The City of Burlingame

January 18, 2002

**Subject: City of Burlingame Comments on the Tentative Order Dated
December 21, 2001, Reissuing NPDES Permit No. CA0037788**

Figure 1. Comparison of normal probability plots and estimated IPBLs.

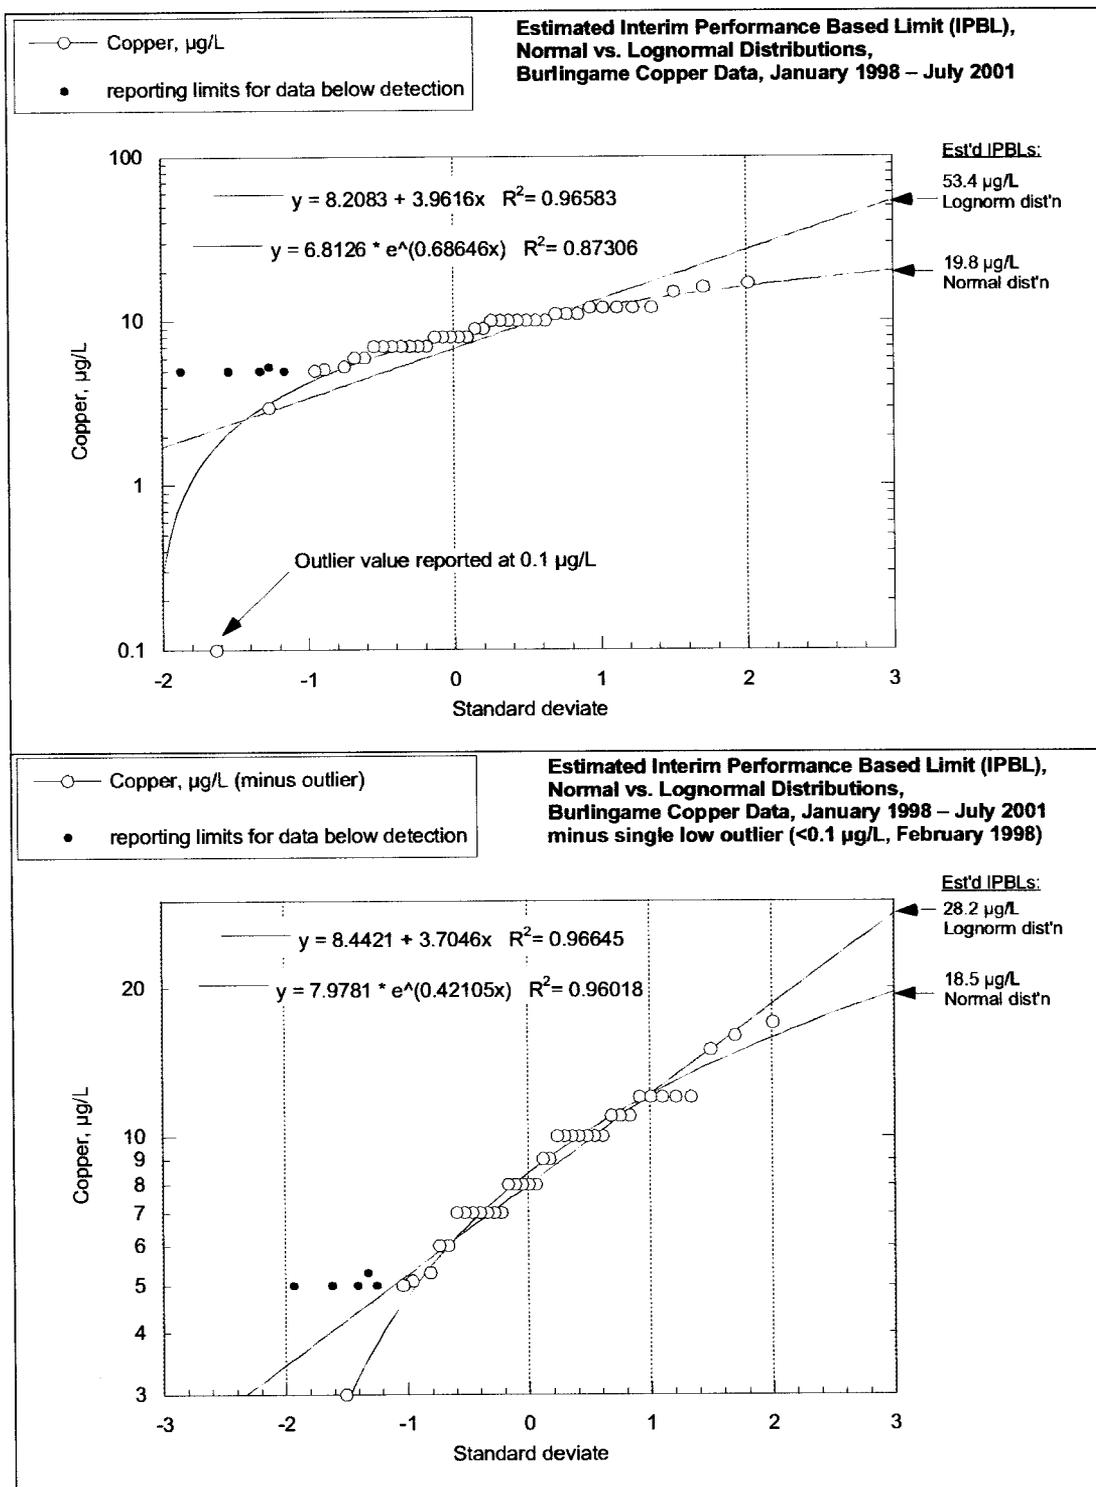
Initial evaluation of the data set including the low outlier of 0.1 µg/L suggests that a normal distribution describes the data better than a log-normal distribution ($R^2 = 0.97$ and 0.72 , respectively; see attached figures). There are several reasons to be suspicious of this outcome, however. The reported copper concentration of 0.1 µg/L is a very unlikely result, based on the fact that this concentration is 1/30th of the next lowest value and is also much lower than copper concentrations in the drinking water supply. Although quality assurance data are not available for more in depth analysis, it is more likely that this result was incorrectly reported or that the result is for an incorrectly labeled blank sample. Additionally, effluent quality data typically conform better to a lognormal distribution because the distribution of concentrations is "left-bounded", i.e. concentrations can not be less than zero. In this case, an assumption of a normal distribution results in an IPBL of 19.8 µg/L, very close to the maximum observed concentration in Burlingame's effluent (17 µg/L), and also predicts that approximately 2% of Burlingame's effluent copper concentrations are less than zero. Excluding the low outlier results in no significant change in the fit for the normal distribution and a greatly improved fit for the log-normal distribution, with R^2 values that are virtually identical for the two distributions ($R^2 = 0.97$ vs. $R^2 = 0.96$, respectively). Overall, it was concluded that a log-normal distribution is a more appropriate model for Burlingame's copper data than a normal distribution.

The Regional Board also independently calculated an IPBL of 25 µg/L based on a log-normal distribution of the same 1998-2001 effluent data (with the low outlier excluded). However, the calculation used by the Regional Board excluded all of the data below detection, on the basis that there were sufficient detected data to characterize the distribution without using the recommended log-probit method (e-mail comm. to LWA, from Regional Board, 1/15/02). Although, no specific thresholds for adequate numbers (or percent) of detected data were cited, excluding data below detection—at any percentage of the data—is an inappropriate method for calculating IPBLs, as well as being inconsistent with Regional Board's recommended method. Excluding data below detection from the analysis reduces the variability and standard deviation of the data set and therefore results in a systematic low bias in the estimated IPBL, and consequently a systematic increase in the probability of effluent limit violations. It also distorts the distribution of the data, making evaluation of normality difficult. While the magnitude of the bias may not be great in this particular case, the precedent set by this method should be opposed because the systematic bias increases in proportion to the percentage of censored data (demonstrated using Burlingame's data in Figure 2). In Burlingame's case, the resulting Cu IPBL calculated by the Regional Board of 24.4 µg/L is

approximately 11% lower [more stringent] than an IPBL correctly calculated using the log-probit method, and is consequently expected to result in a higher probability of violating the IPBL.

Based on this evaluation of the data and distributions, it is concluded that the copper IPBL should be based on a log-normal distribution, with the low outlier excluded. Calculation of the IPBL based on a log-normal distribution provides an interim Cu limit of 28.2 µg/L. This estimated IPBL is significantly lower than the Burlingame's previous permit limit (37 µg/L), but should continue to allow Burlingame to comply with copper effluent limitations. Because the estimated IPBL based on the 1998-2001 copper data is lower than Burlingame's previous NPDES limit, it is expected that the newly estimated IPBL would supercede the limit from the previous permit.
